UNITED STATES PATENT AND TRADEMARK OFFICE

APPLICATION NO.	FILING DATE	FIRST NAMED INVENTOR	ATTORNEY DOCKET NO.	CONFIRMATION NO.
10/708,928	04/01/2004	Kerry D. Hinson	60680-1780	2927

Office Action Summary

DETAILED ACTION

Baumann US-4,684,103

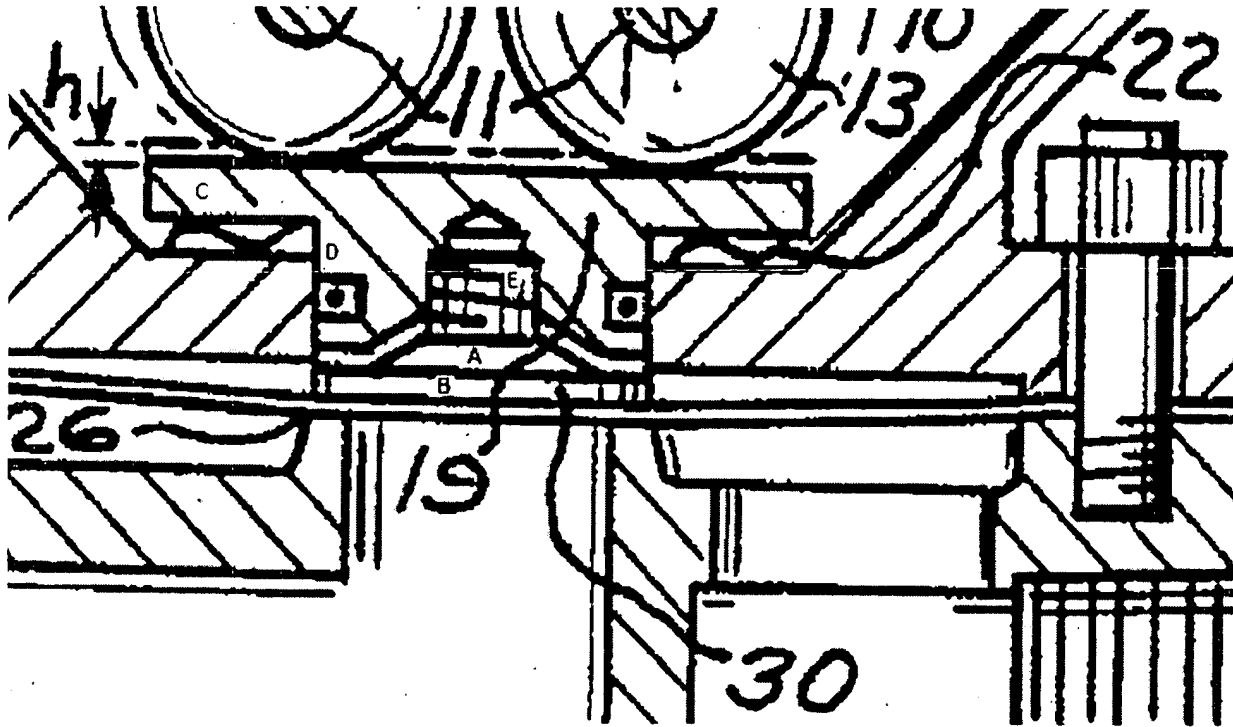
[13] Claims 1 and 3-8 are rejected under 35 U.S.C. 102(b) as anticipated by or, in the alternative, under 35 U.S.C. 103(a) as obvious over Baumann US-4,684,103.

In short, Baumann teaches: a fastener assembly having a threaded fastener (30) having a head portion (A) and a shaft portion (E), a retention sleeve (19) disposed about the threaded fastener (30), and a wave spring (22) disposed about the retention sleeve (19), said wave spring

having an inner diameter slightly larger than an outer diameter of the retention sleeve (19). The fastener assembly acoustically decouples components (13) and (24).

Note that Baumann suggests a radially projecting collar (B) on the head portion (A) of the threaded fastener (3), pertinent to claim 3.

Note that Baumann suggests a radially outwardly projecting head flange (C) on the retention sleeve (19), pertinent to claim 4.

As for claim 5, the examiner takes the position that it would be obvious to one of ordinary skill in the art to make all components of a metal, as a preferred material, because it has been held to be within the general skill of a worker in the art to select a known material on the basis of its suitability for the intended use as a matter of obvious design choice. *In re Leshin*, 125 USPQ 416. It is also common knowledge to choose a material that has sufficient strength, durability, flexibility, hardness, etc. for the application and intended use of that material.

As for claim 6, the wave spring (22) abuts the retention sleeve (19), such that it never fully compresses (only deflects a distance h in a compressed state).

Note that the retention sleeve (19) has a downwardly extending "necking portion" (D), that extends downward from the flange section (C).

Hu et al. US-6,745,995

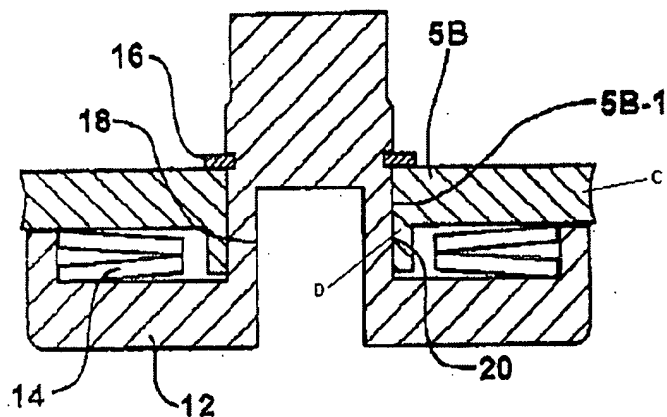
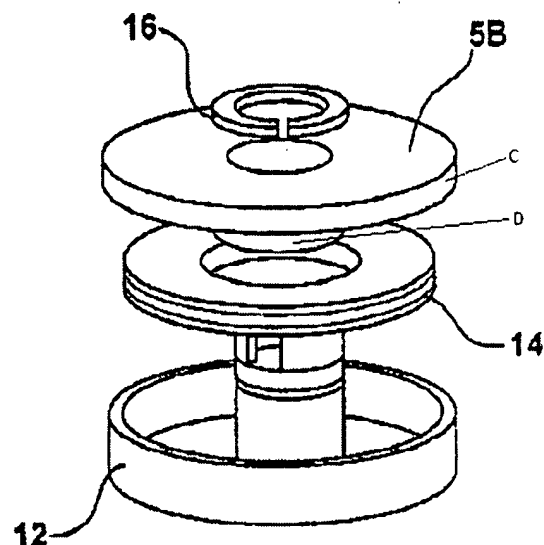
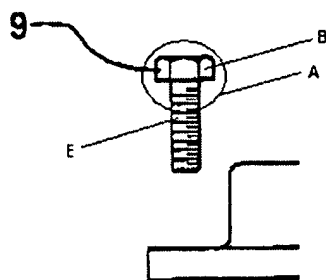
[14] Claims 1 and 3-8 are rejected under 35 U.S.C. 102(b) as anticipated by or, in the alternative, under 35 U.S.C. 103(a) as obvious over Hu et al. US-6,745,995.

In short, Hu et al. teach: a fastener assembly having a threaded fastener (9) having a head portion (A) and a shaft portion (E), a retention sleeve (5b) disposed "about" the threaded fastener (9), and a wave spring (14, col. 5 lines 48-50 & 56-57) disposed about the retention sleeve (5b), said wave spring having an inner diameter slightly larger than an outer diameter of the retention sleeve (5b). The fastener assembly acoustically decouples components (16) and (12).

Note that Hu et al. suggest a radially projecting collar (B) on the head portion (A) of the threaded fastener (9), pertinent to claim 3.

Note that Baumann suggests a radially outwardly projecting head flange (C) on the retention sleeve (5b), pertinent to claim 4.

As for claim 6, the wave spring (14) abuts the retention sleeve (5b), such that it never fully compresses.

Note that the retention sleeve (5b) has a downwardly extending "necking portion" (D), that extends downward from the flange section (C).
